**CITY OF ELKO
WATER MAIN REMOVAL AND
REPLACEMENT PROJECT
ADDENDUM NO. 2
FEBRUARY 7, 2018**

ADDENDUM NUMBER TWO
to the
**WATER MAIN REMOVAL AND
REPLACEMENT PROJECT
BID DOCUMENTS, SPECIFICATION AND
PLANS**

NO.	REVISION	DATE	STANDARD DETAILS FOR PUBLIC WORKS CONSTRUCTION	SECTION ROADWAY	
			PAVEMENT PATCH	DRAWING NO. R-9.1	
			CITY OF ELKO, NEVADA	DATE 11/30/07	PAGE 1

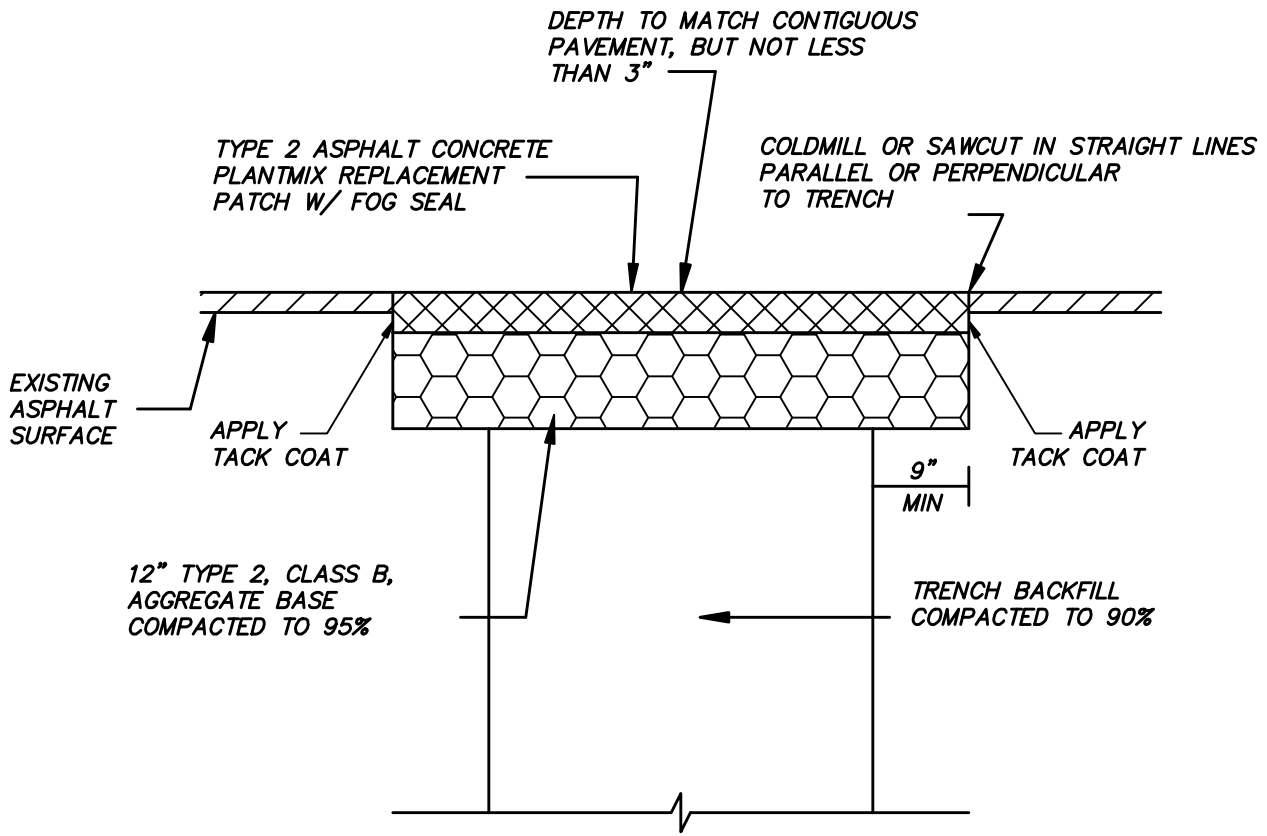
- 4) Asphalt patching of existing streets will be required at the points of connection at A Street, 1st Street, 3rd Street, 11th Street, Front Street, and Wilson Avenue. The City of Elko Standard Detail for Pavement Patch is attached to this Addendum No. 2.
